1020000 MAINTENANCE OF TRAFFIC
COMMENTS FROM INTERNAL/INDUSTRY REVIEW

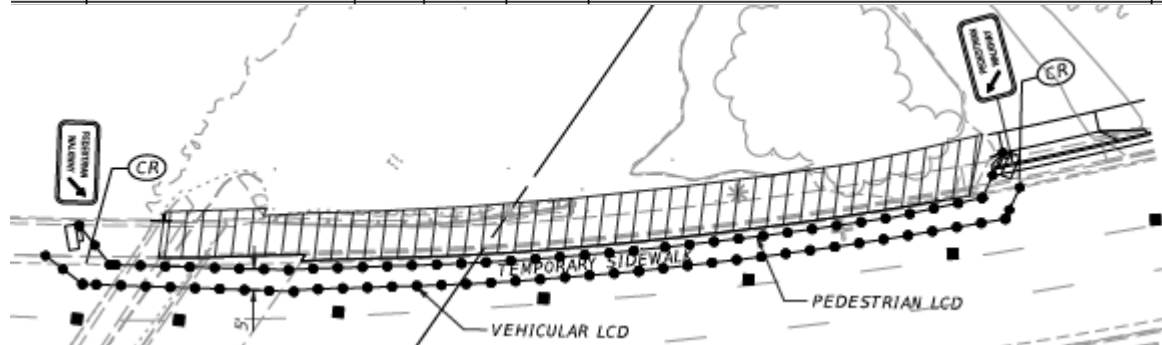
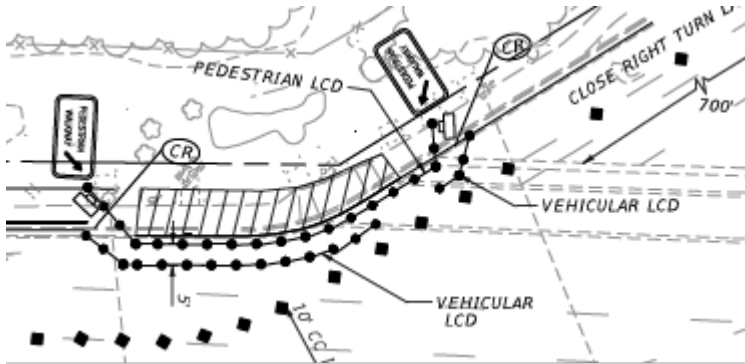
Finally, it is not listed on any of the memo but there should be a line item distinction for pedestrian LCD's and Vehicular LCD's. They are definitely not the same item but as a source of example they were bid under the pedestrian LCD item on this recent Central Letting.

T4522 Bid, the pay item 0102 74 7 for LCD's include some "vehicular LCD's" to be used at the 2 locations where the Pedestrian Special Detour 2 are to be built, to move pedestrians from the sidewalk to the actual roadway.

7. Vehicular LCDs will no longer be an option and the pay item removed for July 2020 lettings and later. Pedestrian LCDs will remain as a separate pay item. No change made.
